Our Ref. 21123

11 November 2021

RE: PROPOSED MINOR CHANGE TO THE EXTERNAL FINISH OF THE NORTHWEST CORNER OF APARTMENT BLOCK 01, NOW KNOWN AS 'AIRLIE PARK VIEW' PERMITTED UNDER SDZ20A/0017.

Figure 3: Extract from Drg. No. 2012 PA3 APT 05 prepared by Conroy Crowe Kelly Architects & Urban Designers denoting the proposed material changes to the North and West Elevations of Block 01 as highlighted in Figure 1.

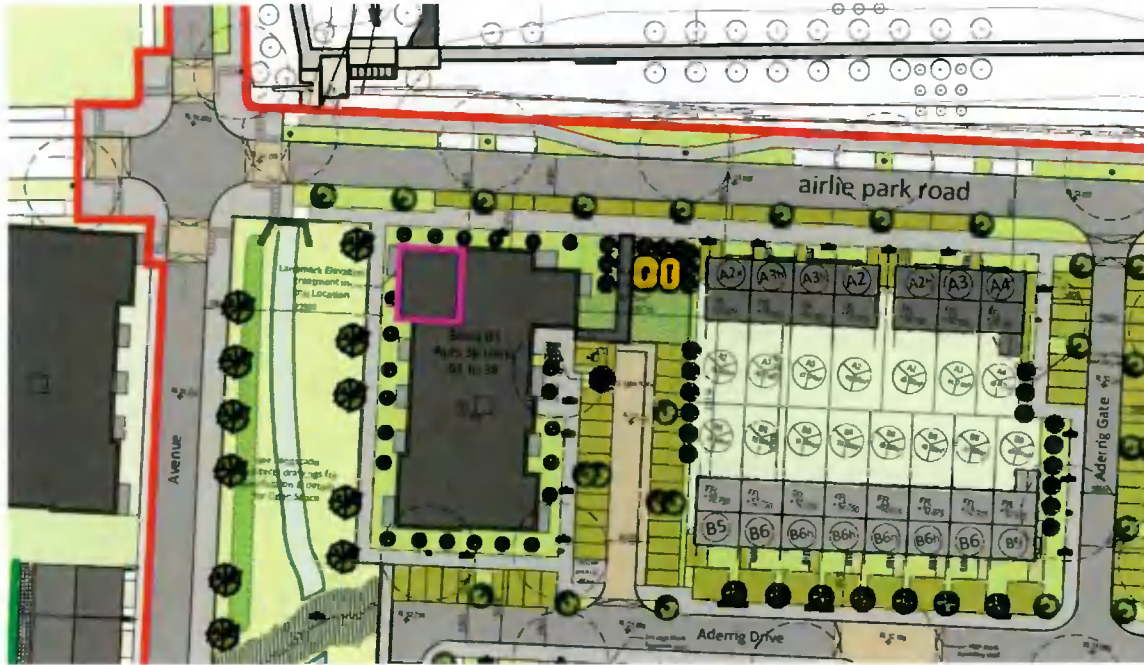
Figure 1 above highlights the specific area of the Aderrig phase 1 site directly affected by the proposed development as set out in this amendment permission application. Whilst Figures 2 and 3 respectively denote the permitted stone cladding on the northwest corner and the proposed material changes to the external finish to dark grey/black brick on the corner of this landmark apartment block.

The proposed amendment seeks to change the permitted stone cladding to dark grey/black brick, as seen in figure 3 above, consisting of either the Lithium or the Livorno type, depending on availability to provide the building corner of Block 01 the landmark status it warrants. We refer the Planning Authority to the enclosed Architect's Report, prepared by Conroy Crowe Kelly Architects which includes technical information sheets of both these brick types as well as of the buff brick type for the rest of the block.
